Title: Cavalon low fuel float re	elease date 01.Apr. 2019		
SB-132 Iss1	Related documents Modification: MC-411 CCAR No.: CCAR-081	Compliance Category:  OPTIONAL or	
Applie	RECOMMENDED or		
Aircraft type & model: Cavalon	Aircraft serial Nos. affected: Any RotorSport Cavalon to ser 030	MANDATODY	
The maintenance manual to be referenced is this stated or subsequent issue.		e. Cavalon RSUK0288 Iss 5

### Reason and overview of the Service Bulletin (cause of problem if known

Photo showing the brass split pin and the float with the marked dot (which is fitted uppermost)

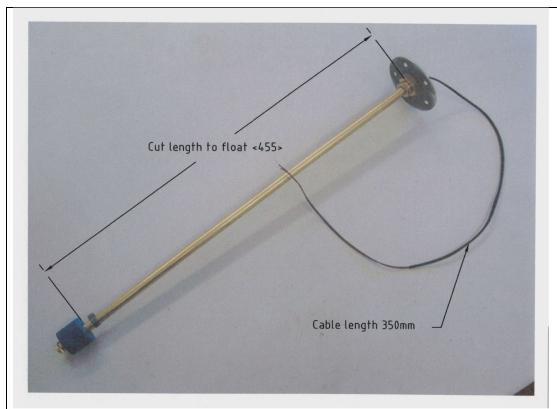
This float has been found to sometimes absorb fuel, depending on the fuel type used and altitudes operated at.

Absorption of fuel means that the float has less buoyancy, and causes a low fuel warning when in excess of the fuel low fuel warning level is in the tank.

This bulletin is to replace this float with a denser float material, which is less susceptible to fuel ingress and altitude changes.

- 5. Remove the low fuel sensor from the tank. Tank care not to drop the underside clamp ring into the tank.
- 6. Remove the brass split pin from the bottom of the sensor rod. A new pin is supplied with the new float.

- 7. Remove the blue float and discard. Replace with the new float, with the dot uppermost.
- 8. Refit the split pin and fold out the pin.
- 9. Refit the sensor assy as a reverse of the previous instructions. Use Loctite 5331 sealant on the mating surfaces to seal the assy to the tank.
